## Accessibility Survey

## City of Downey I 105 East Ramp & Lakewood Boulevard

I 105 East Ramp & Lakewood Boulevard  
Downey, CA 90242

Date of Inspection  
5/24/2017

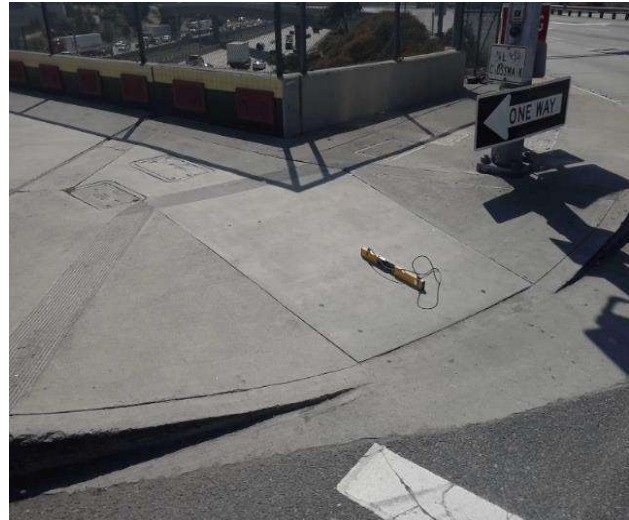
The curb ramp does not provide a detectable warning surface which includes truncated domes.

**On-Site Finding** Not Found

Provide compliant detectable warnings to surface.

Provide detectable warning to surface \$248

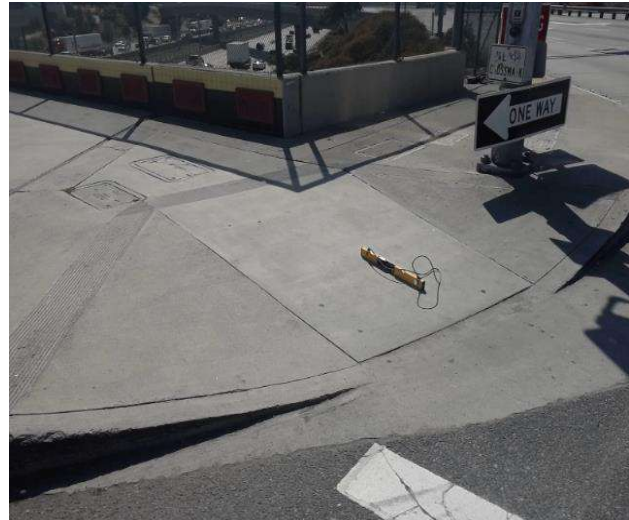
The slope of the curb ramp side flare is greater than allowed.

**On-Site Finding** 12.20 percent

Provide curb ramp side flares with a compliant slope.
